ADDENDUM # 2

Gatton Business and Economics Suites Renovation Room 144

ADDENDUM NO. 1

TO THE DRAWINGS AND SPECIFICATIONS
FOR THE
GATTON COLLEGE OF BUSINESS & ECONOMICS SUITE 144 RENOVATION
MAY 22ND, 2023

Part 2 – Products; change heading to read “2.04 Carpet Tile CPT-2-Broadloom”; add and change the following:

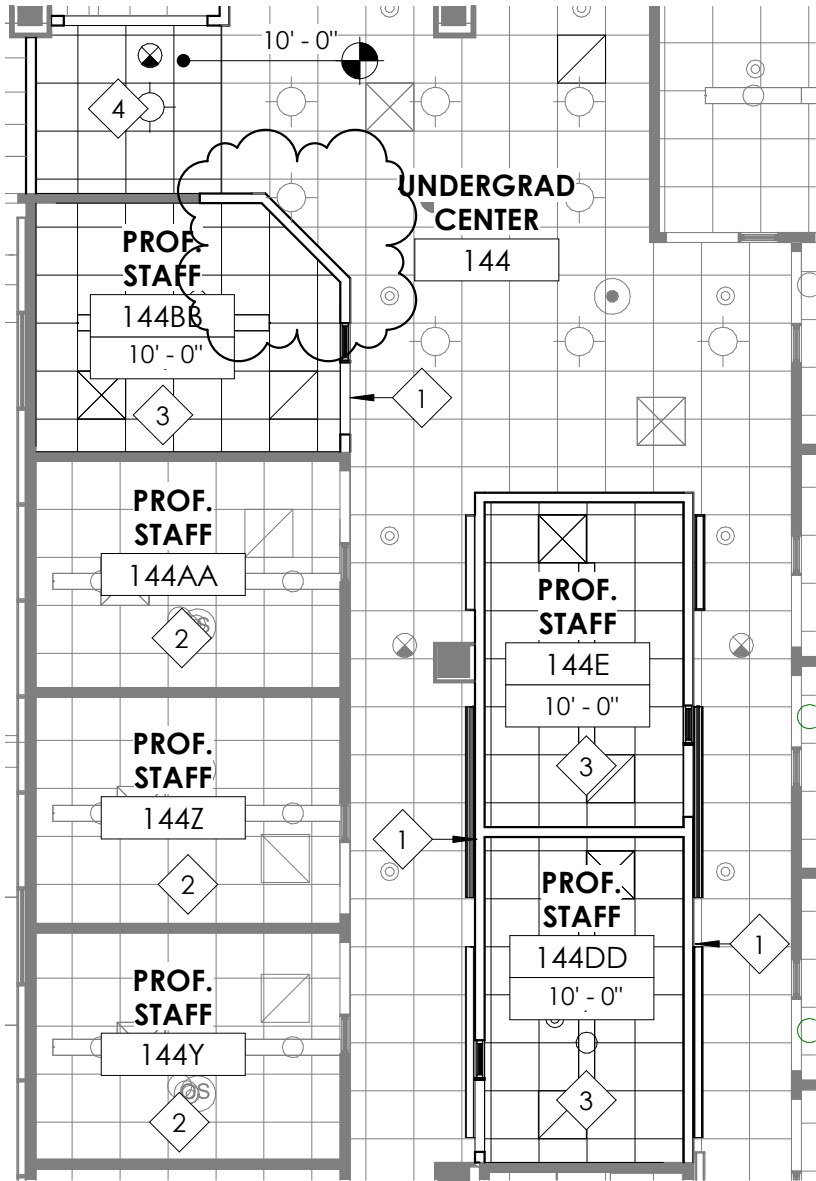
2. Refer to Architectural Specifications Section 096813 Carpet Tile and Base, Change Heading to read “Carpet Tile and Broadloom”; also change/add the following:

Part 1 – General; 1.01 Section Includes; A.; change to read “This Section includes modular, tufted carpet tile (CPT1-Tile and CPT2-Broadloom)

- B. Manufacturer: J+J Flooring
- C. Collection: Mix III
- D. Style: Broadloom
- E. Style number: 3512
- F. Color: 1452 Blend
- G. Fiber Content: Encore BCF Nylon
- H. Primary Backing/Backcoating: Premierbac Plus
- I. Dye Method: Solution/Yarn Dyed
- J. Size: 12 Feet
- K. Applied Soil-Resistance Treatment: Manufacturer’s standard material
- L. Antimicrobial Treatment: Manufacturer’s standard material

ADD #1
AD1.0

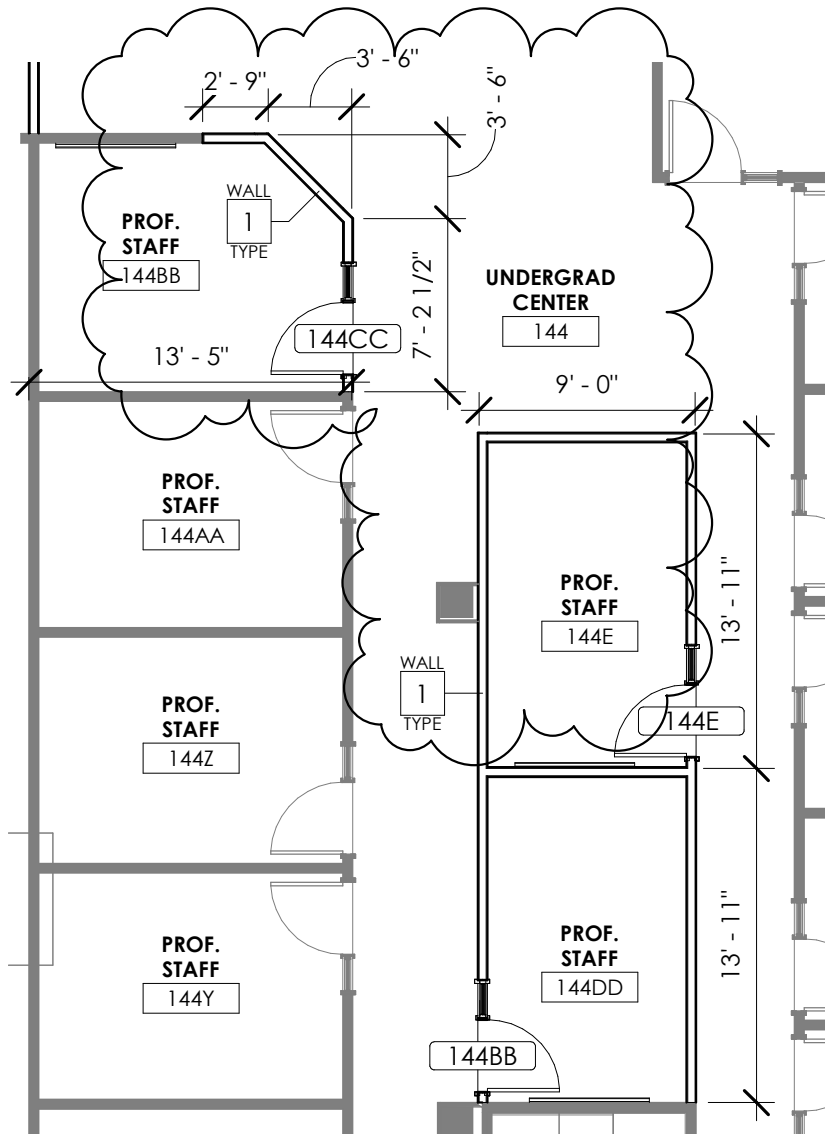
1. Refer to **Drawing Sheet A1.1 - First Floor Plans:**
 - a. Refer to drawing B/A1.1. Revise per attached sketch A/AD1.0.
 - b. Refer to drawing C/A1.1. Revise per attached sketch B/AD1.0.
